Product Change Notice (PCN)

Subject: Change production site of CF/ML process for 8M CMOS image sensor

<Spectral characteristics>

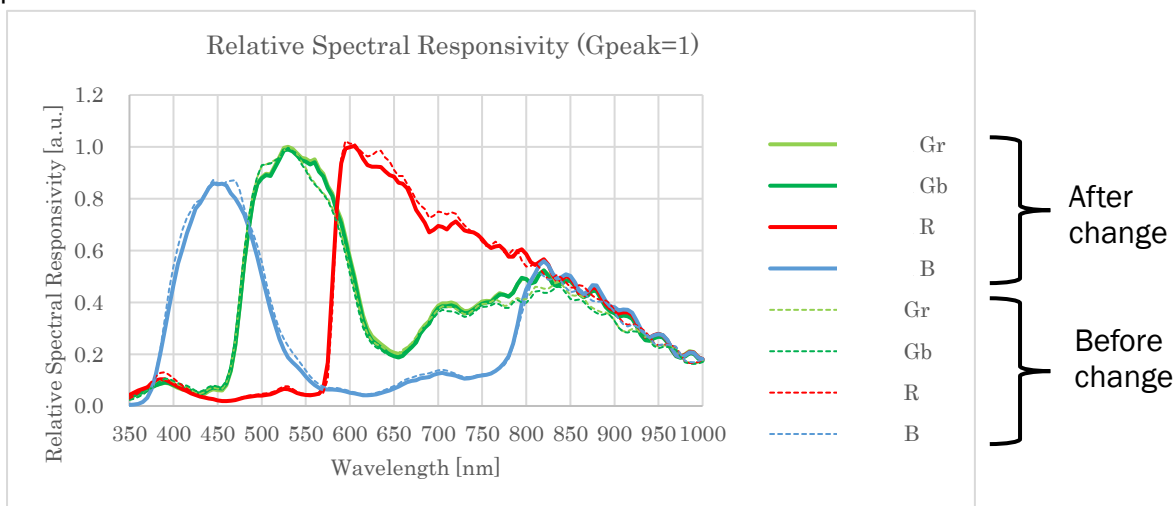
Renesas will change production site of CF/ML (Color Filter/Micro Lens) process from UMC to VisEra.

- Part number will be changed from RAA462113FYL#AC2 to RAA462113FYL#AC6.
- Some specification will be changed.

<Pixel characteristics>

Item	Symbol	Min	Typ	Max	Unit
Before change	Sensitivity ratio B/G	SENS_B/G	64		88	%
After change	Sensitivity ratio B/G	SENS_B/G	55		79	%
